Re: Project Narrative
Town Project No. 2017-05
Fabrizio 2 Lot Subdivision
Gardnertown Road
SBL: 51-9-9
R-1 Zone
Job No. 16293-FAB

TOWN OF NEWBURGH PLANNING BOARD TECHNICAL REVIEW COMMENTS

FABRIZZIO 2 LOT

2017-05

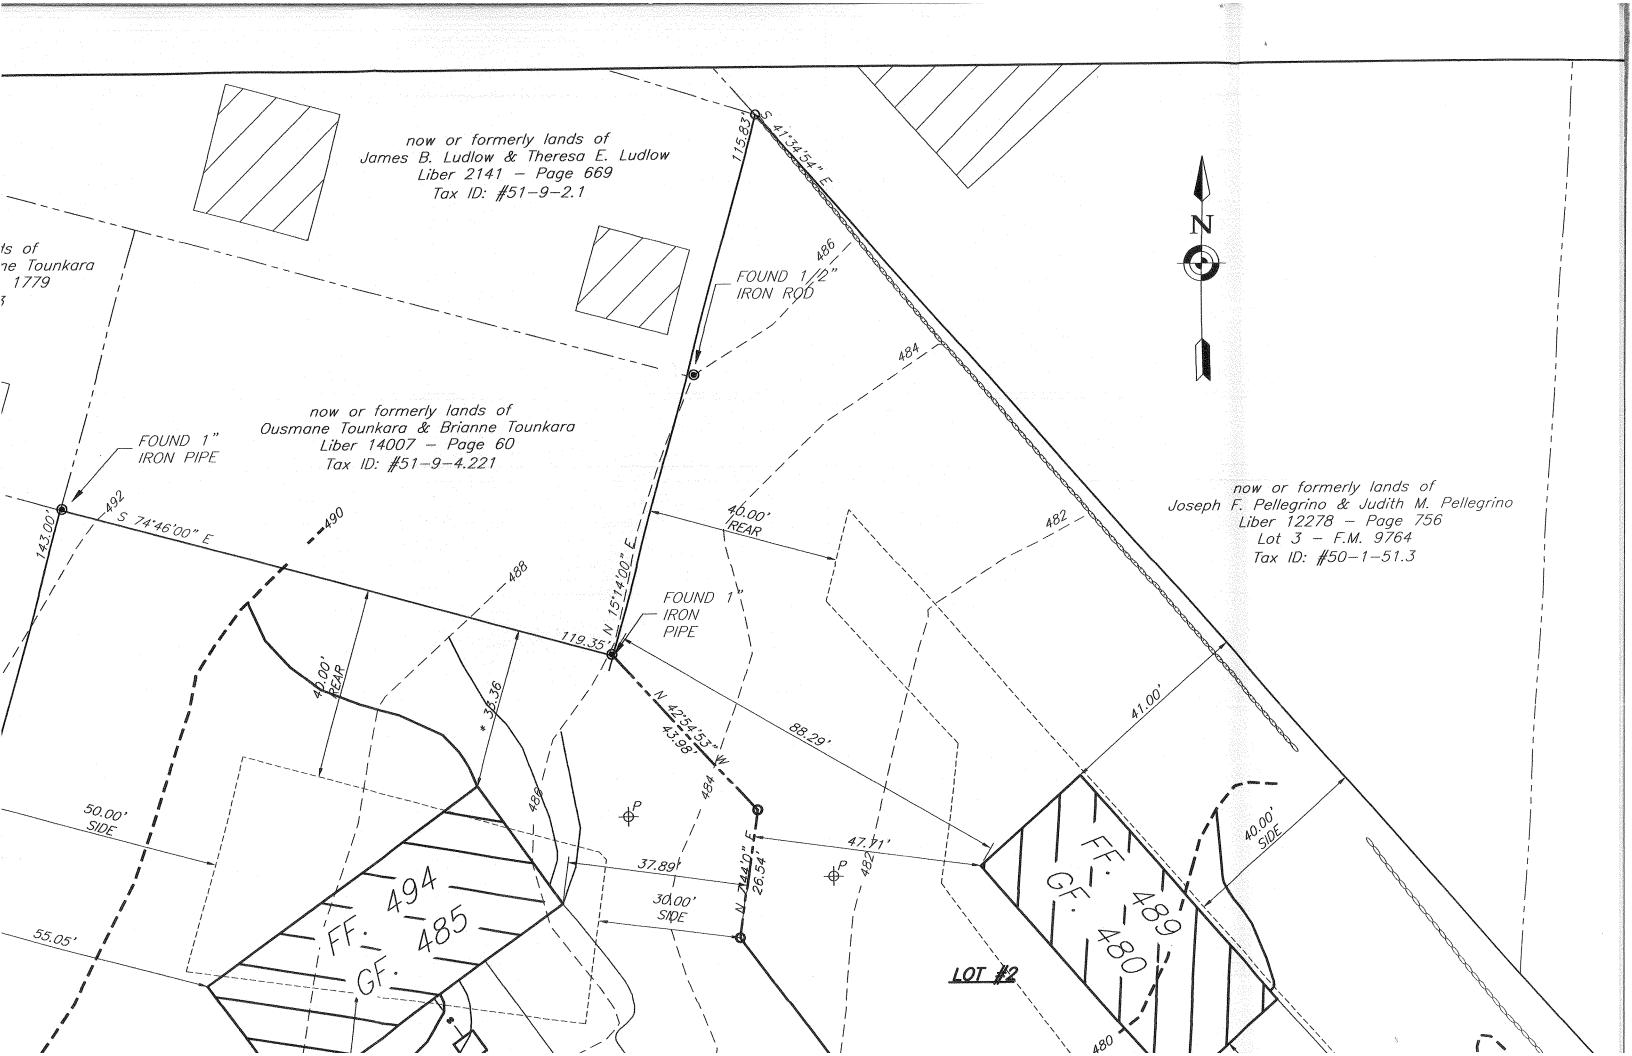
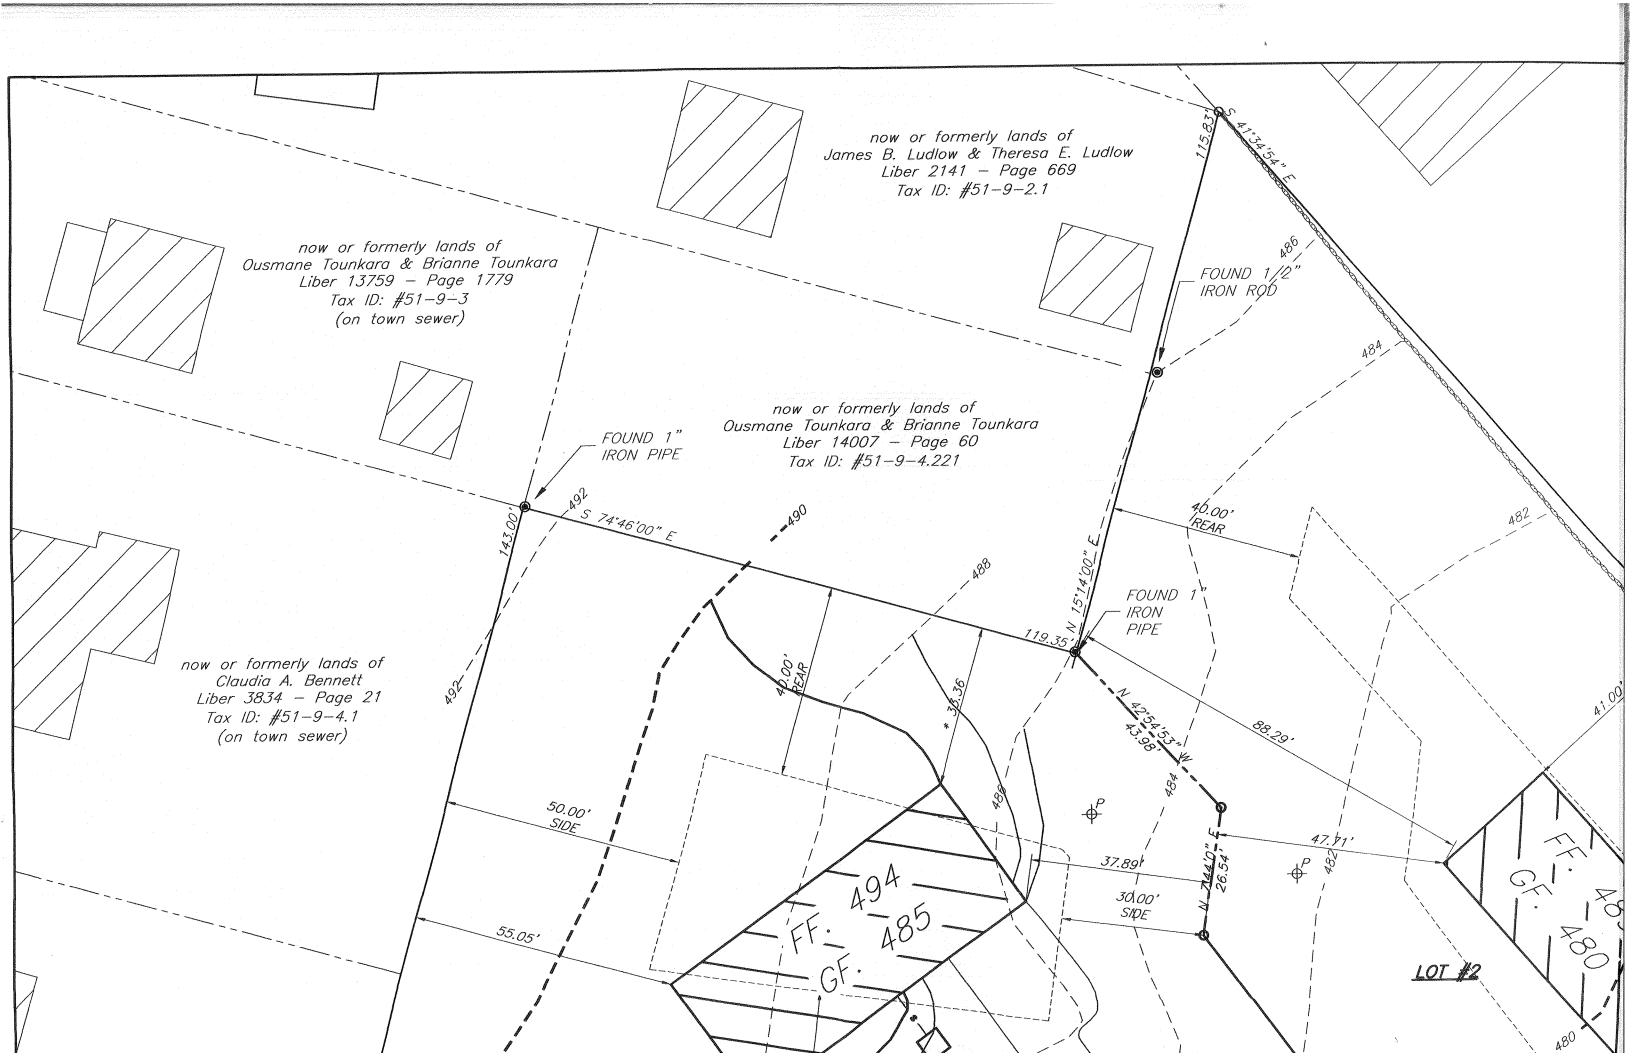
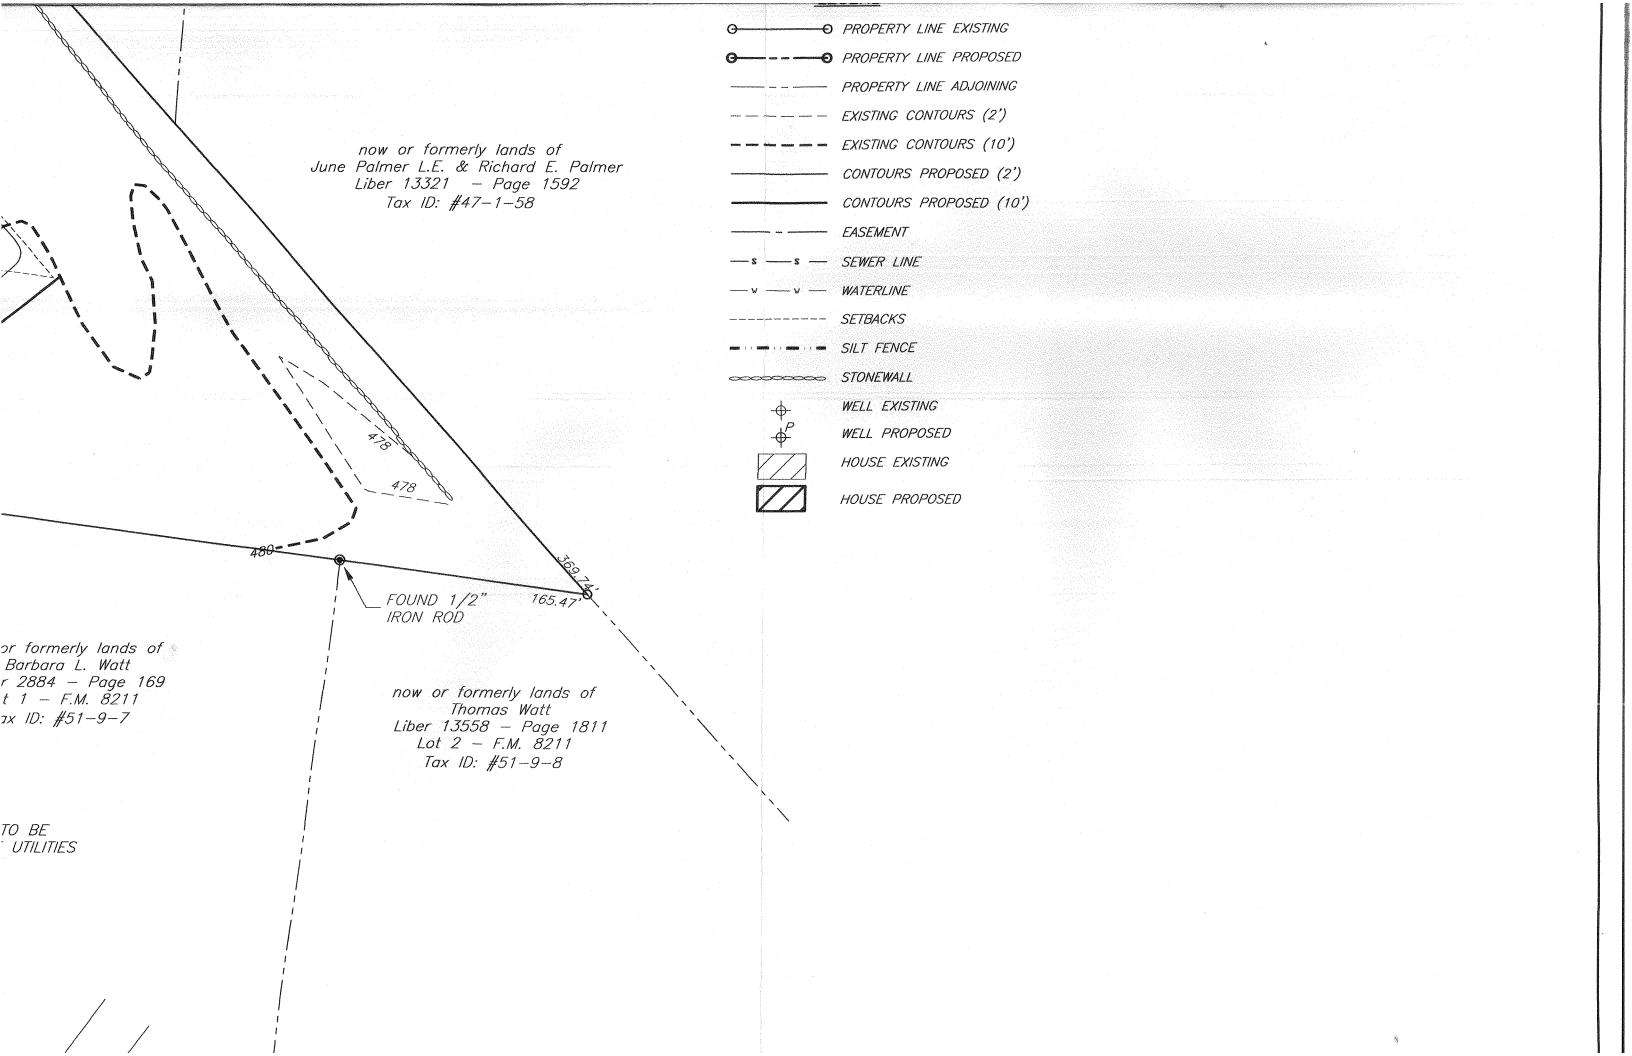
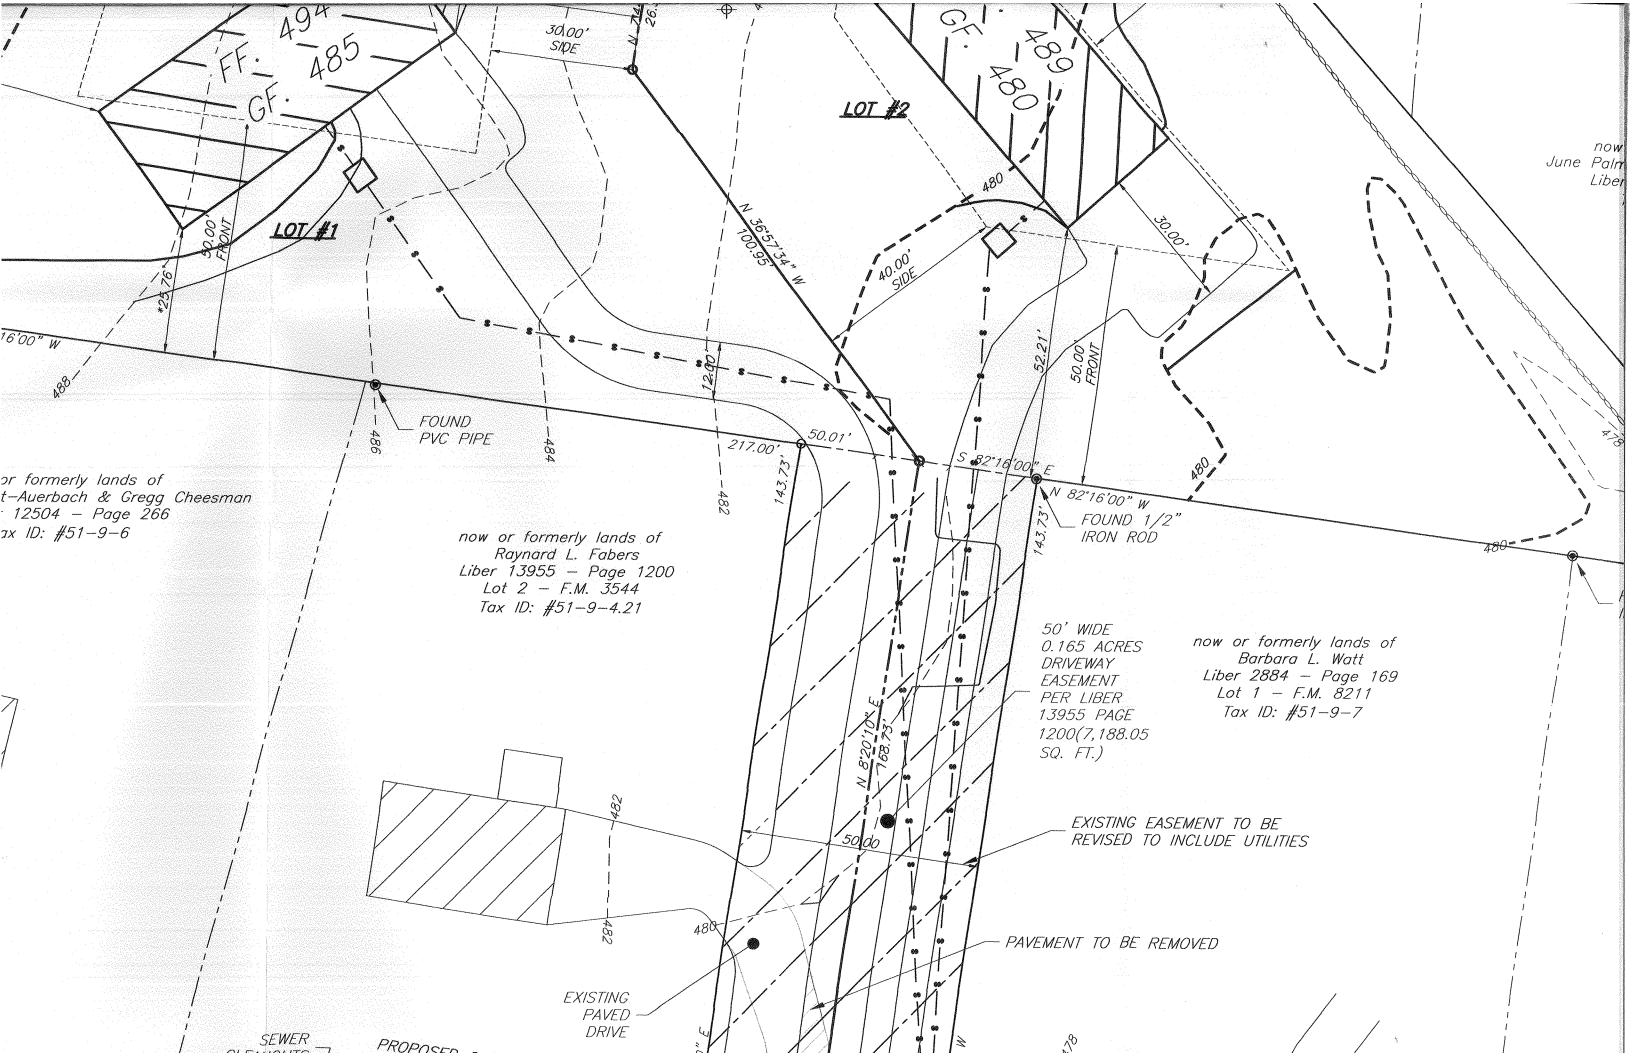
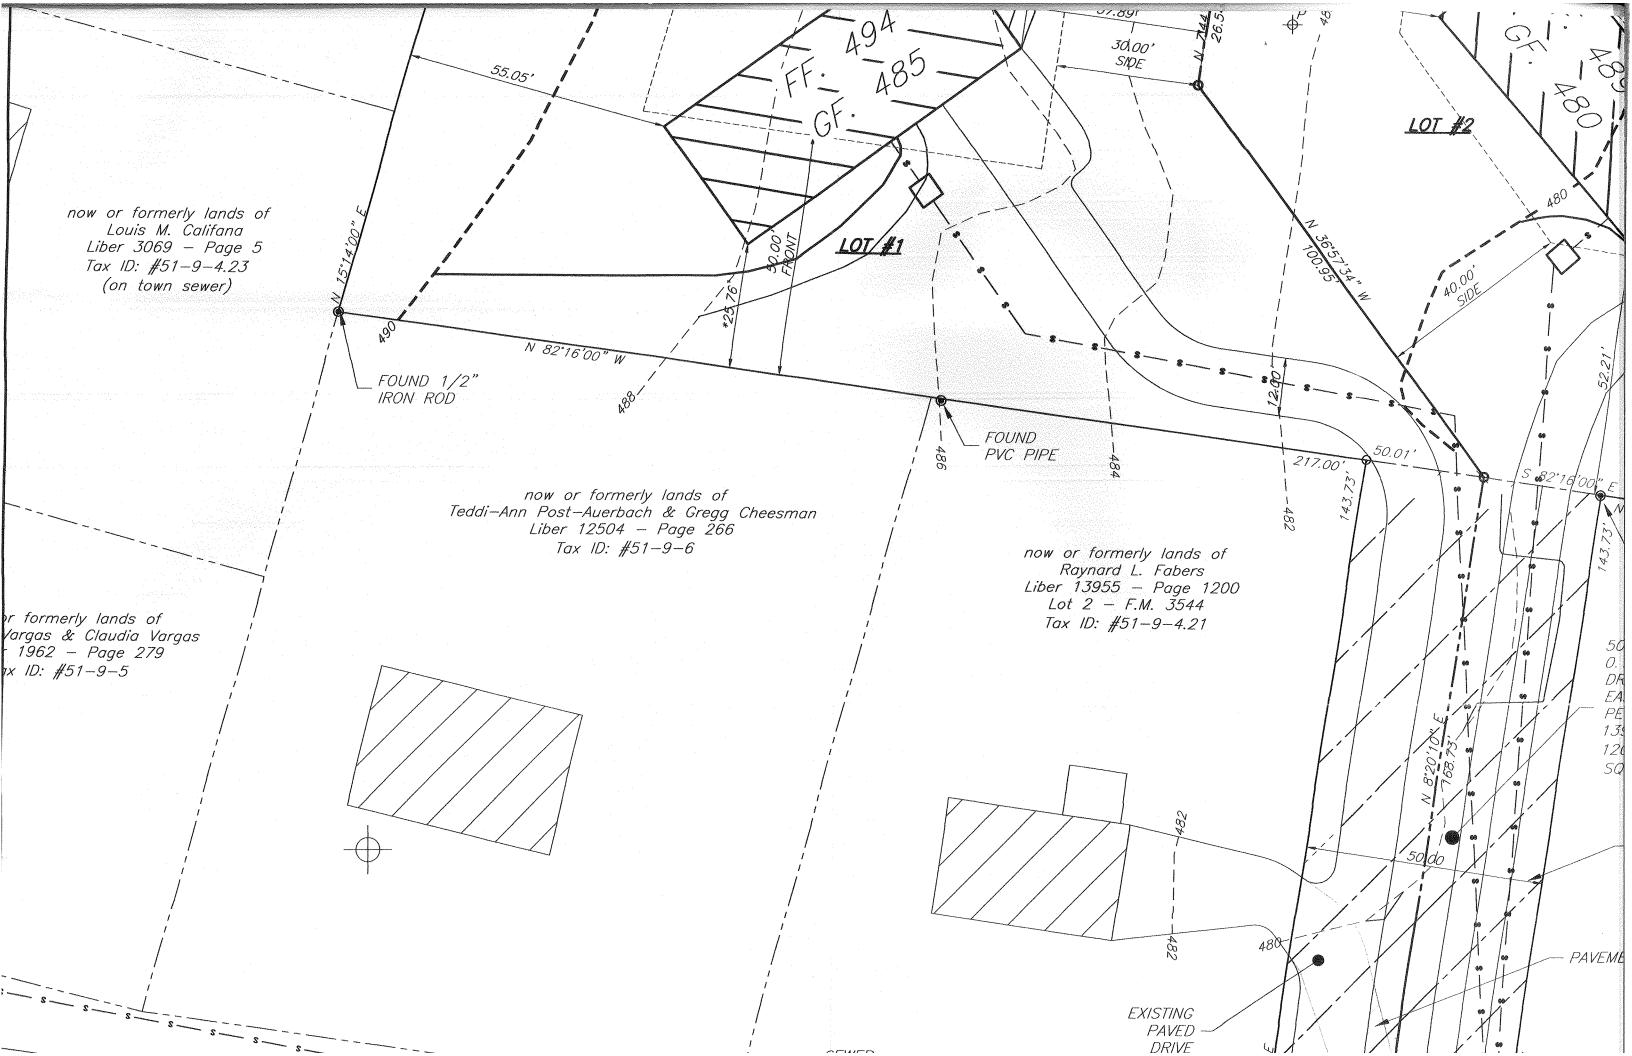
7. Lot #2 structure is depicted at or near building envelope setbacks. Notes should be added to the plans requiring field stake out of all improvements prior to issuance of the Building permit. A plot plan should be submitted to the Building Department with the Building permit.

- 1. The common driveway access and maintenance agreement will be required for the shared driveway for proposed Lot #1 and Tax Lot 4.21.
- 2. Highway Superintendent's comments regarding dual driveway locations should be received.
- 3. The shared utility arrangement will require a filed agreement for the combined sewer discharge.
- 4. NYS raised septic system notes should be removed from the plans as lots are tributary to the Town's collection system.
- 5. The Applicant's representative is requested to explain pump chamber note 5 regarding metering of the wells.
- 6. Referral to Zoning Board of Appeals for front yard setback on Proposed Lot #1 would be required.

We have noted that the structure could be re-oriented to fit within the permissible building envelope. Applicant's representative should explain house orientation.
